| FED. ROAD DIST. NO. | STATE | FEDERAL AID PROJ. NO. | FISCAL YEAR | SHEET NO. | TOTAL SHEETS |
|---------------------|-------|-----------------------|-------------|-----------|--------------|
| HAWAII              | HAW.  | ER-22(002)            | 2019        | ADD 41    | 94           |

| DRILLED SHAFT  |                   |
| PALI HIGHWAY<br>LANDSLIDE MITIGATION PROJECT<br>FAP Proj. No. ER-22(002) |                   |

DRILLED SHAFT 1 AND 2 ELEVATION  
Scale: 1/2" = 1'-0"

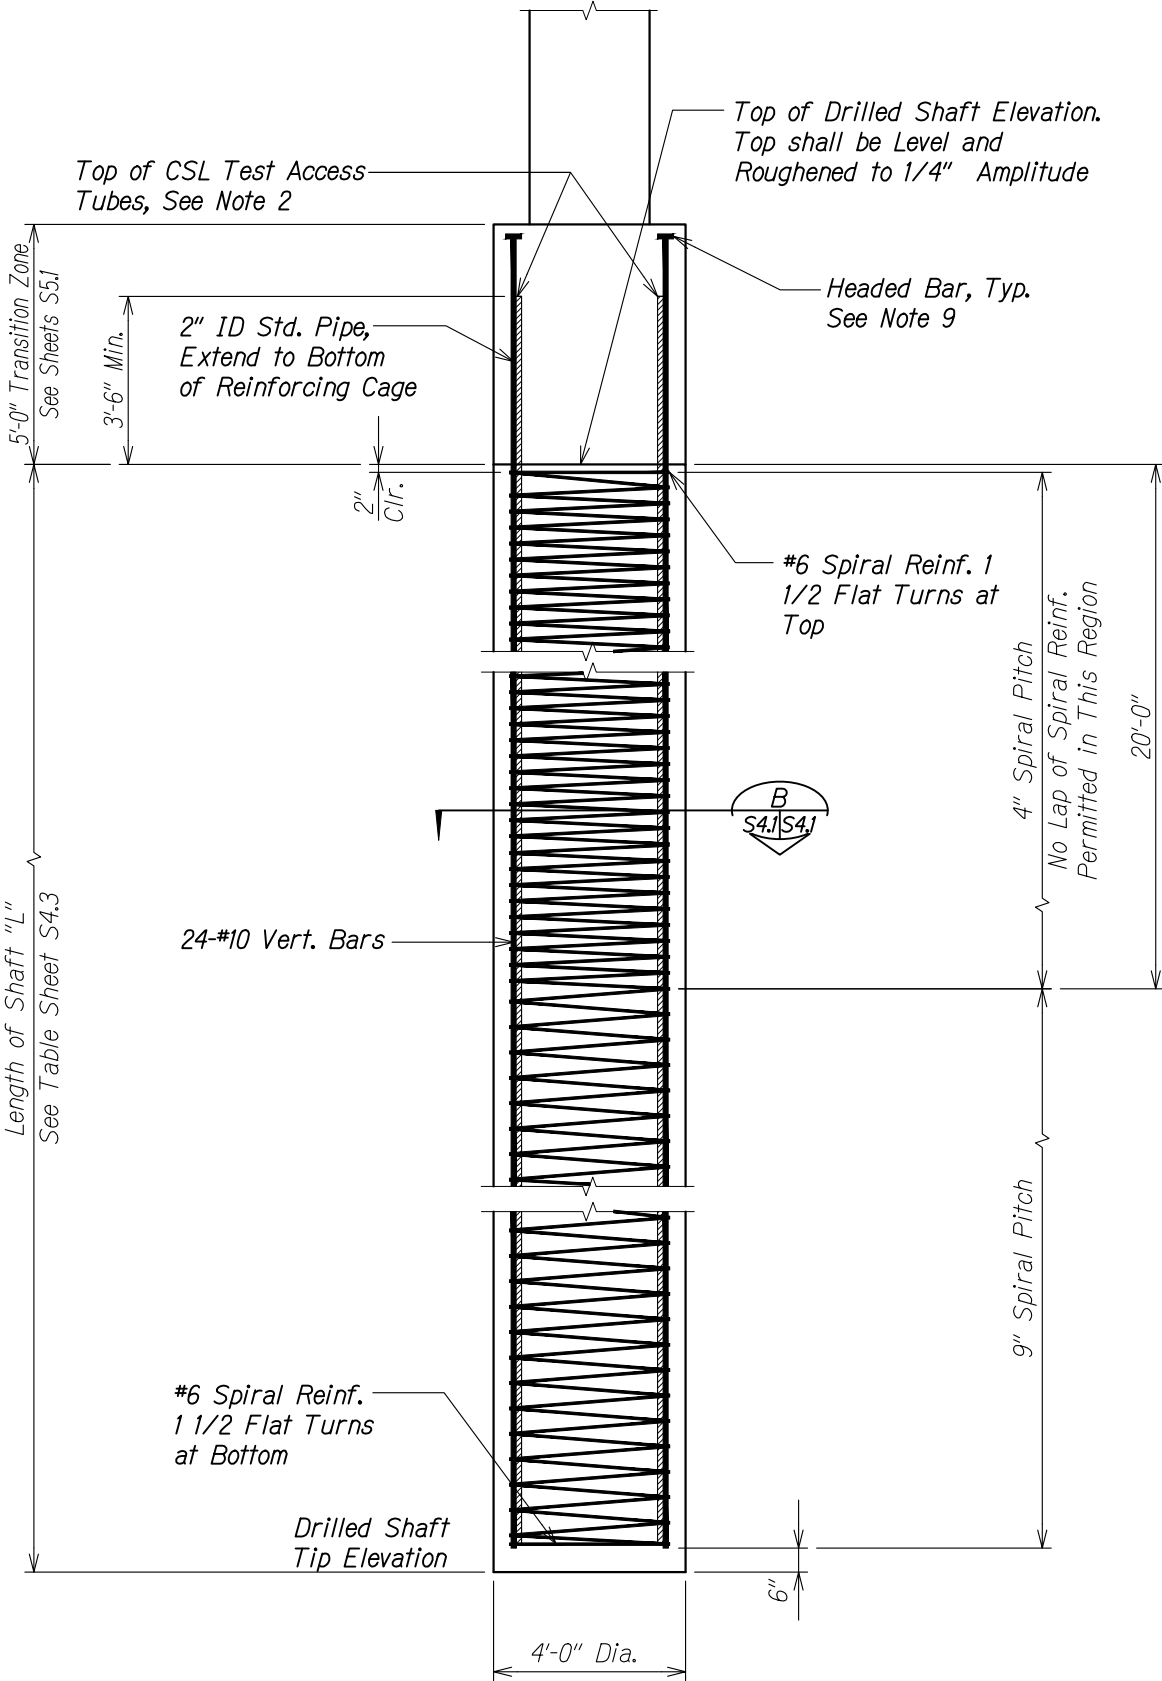
| 5/24/19  | Revised Notes     |

- Lap splice length for #10 vert. bar shall be 6'-6". No lap splices of vert. bars are allowed in the upper 40'-0" of the drilled shaft.
- Lapped splices shall have a minimum of 2'-0" vertically between splice points.

- Bundled bars in the transition zone may consist of one headed vertical bar and one unheaded vertical bar.

DRILLED SHAFT 3 ELEVATION A  
Scale: 1/2" = 1'-0"

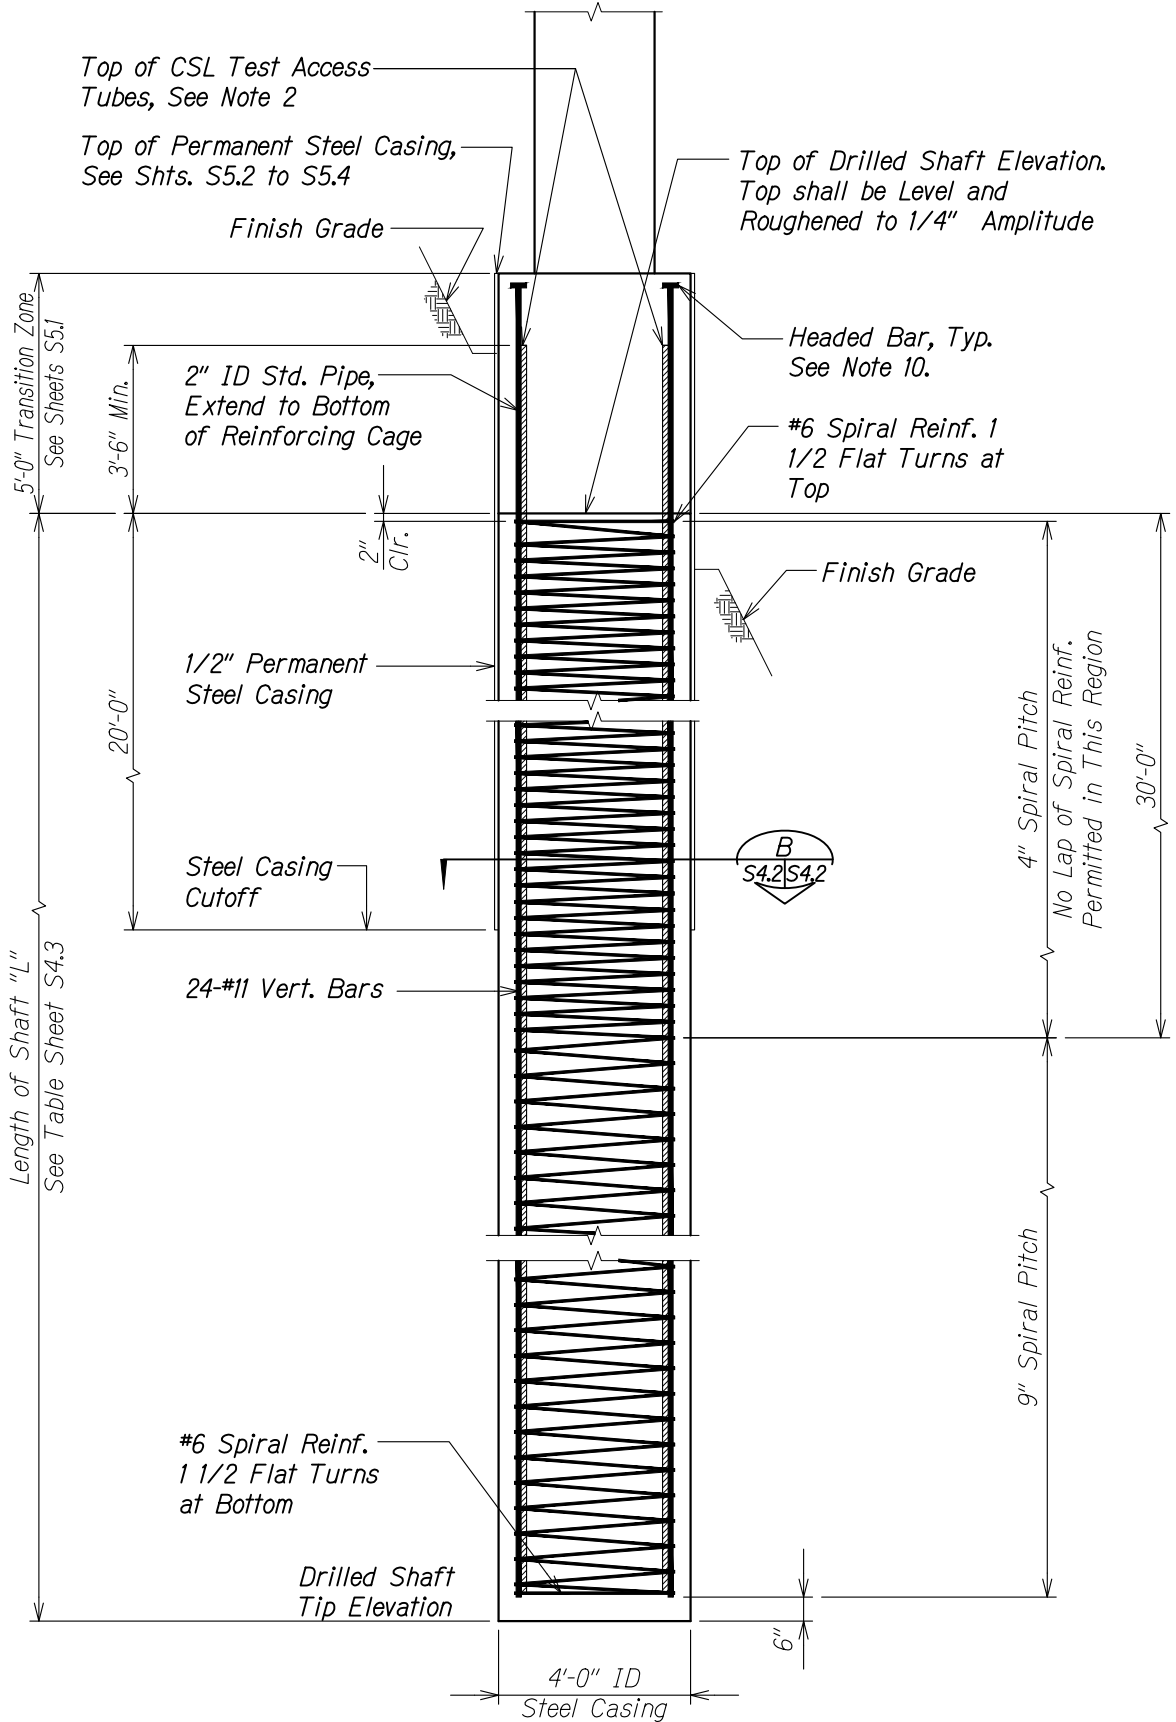
| 5/24/19 | 1 Revised Notes |

- Lap splice length for #11 vert. bar shall be 8'-0". No lap splices of vert. bars are allowed in the upper 40'-0" of the drilled shaft.
- Lapped splices shall have a minimum of 2'-0" vertically between splice points.

- Finish grade shown for illustrative purpose. See civil sheets.
- Bundled bars in the transition zone may consist of one headed vertical bar and one unheaded vertical bar.

**COLUMN SECTION**  
Scale: 1" = 1'-0"

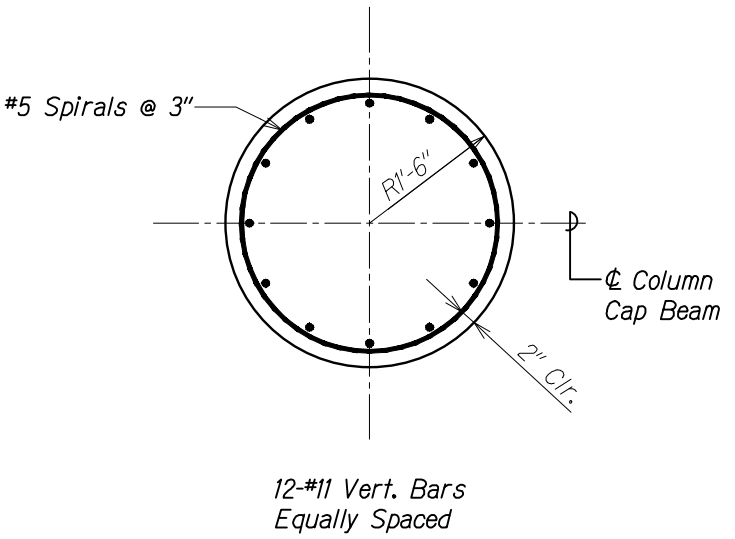
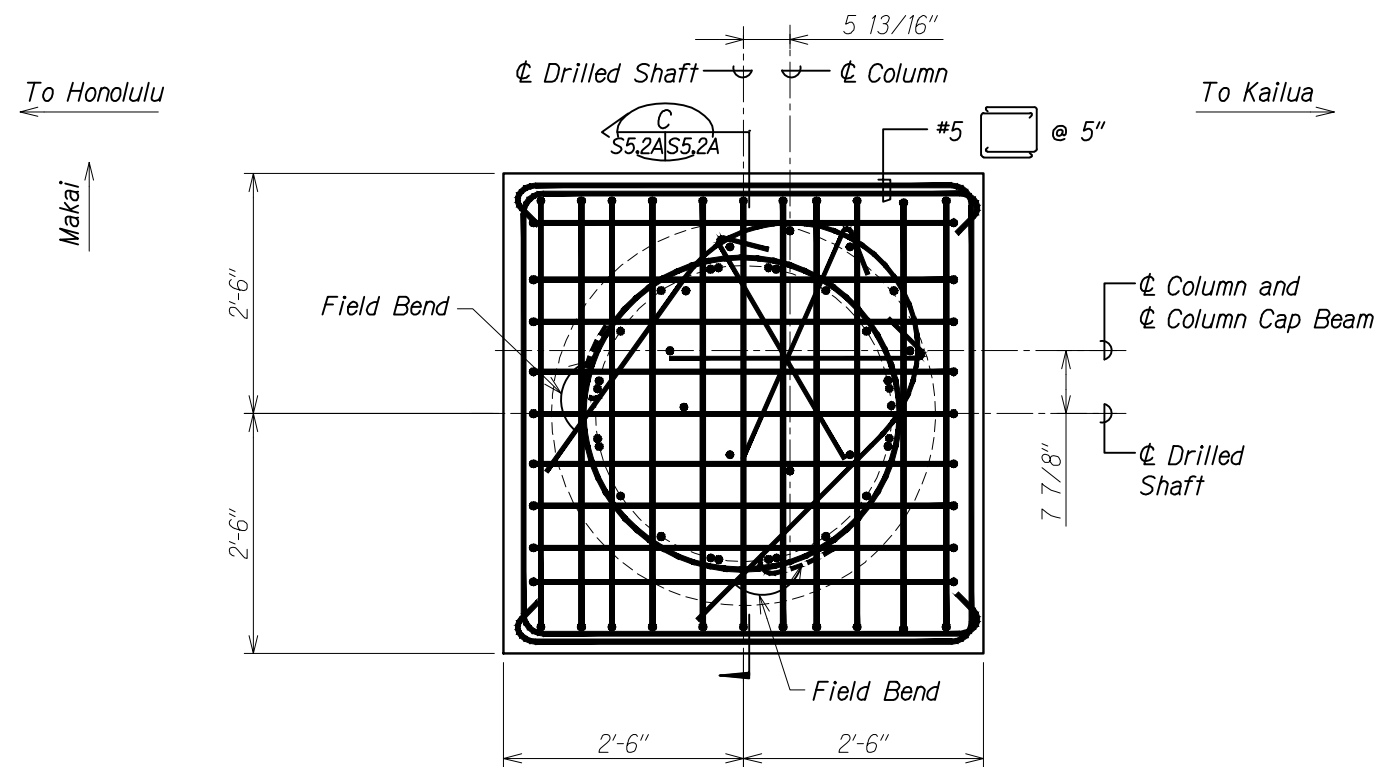
| 6/6/19  |  | <i>Revised Section Based on As-Built Conditions</i> |
| 5/24/19 |  | <i>Revised Section</i>                              |

**TRANSITION ZONE SECTIONS**

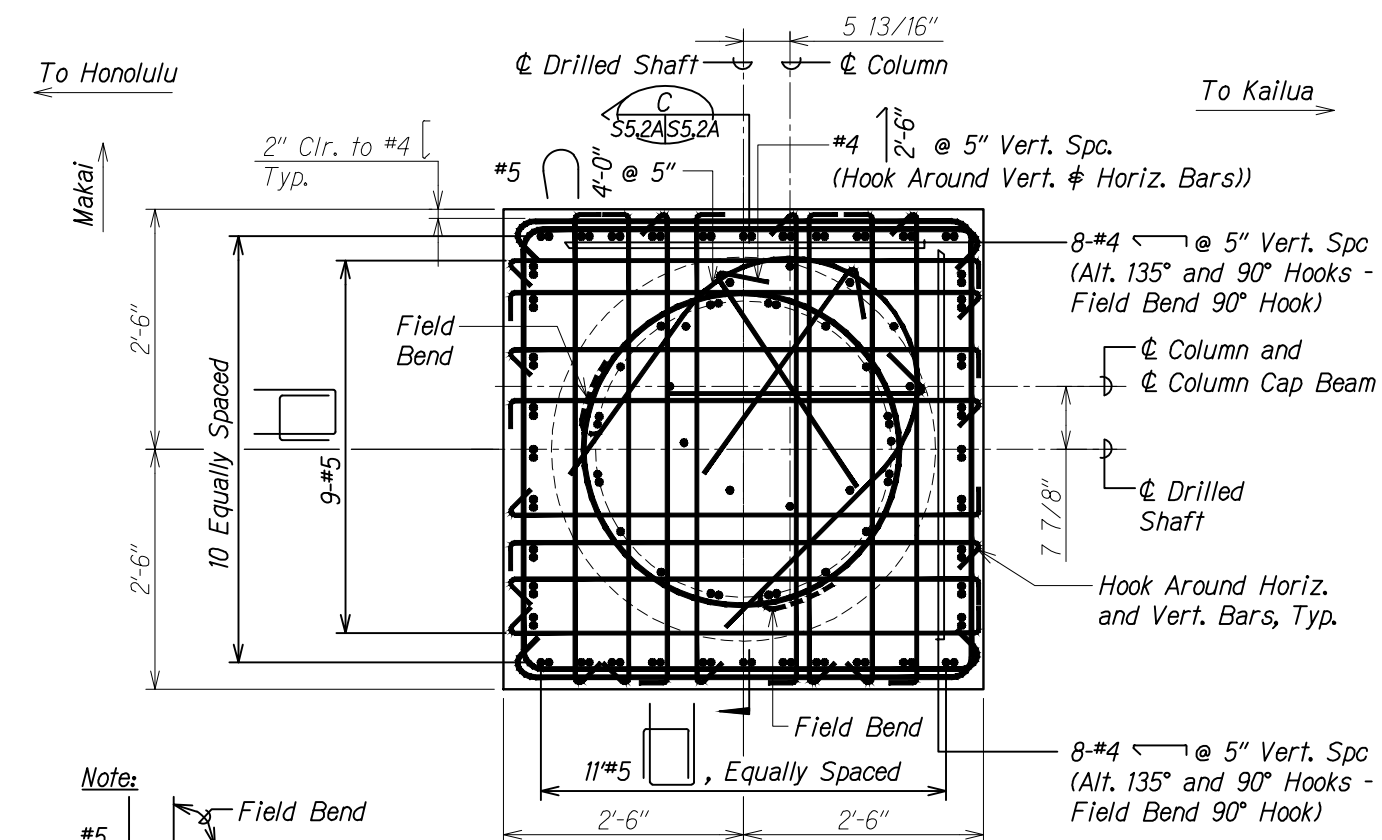
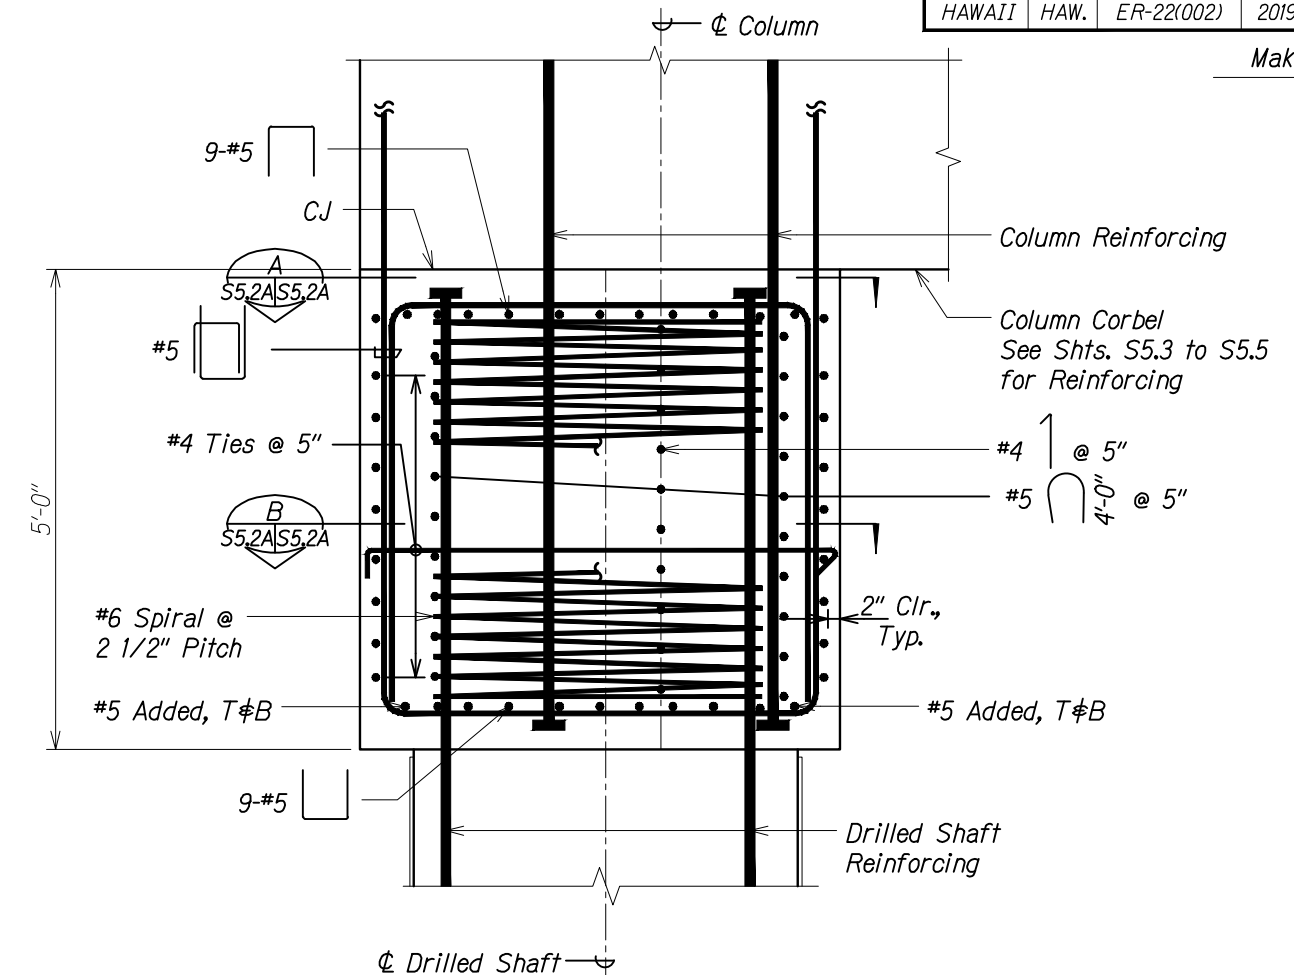
| 6/6/19  |  <i>New Sheet Based on As-Built Conditions</i> |
| 5/24/19 |  <i>Revised Section</i>                        |

#5  *Field Bend*  
after inserting L through  
drilled shaft spirals.
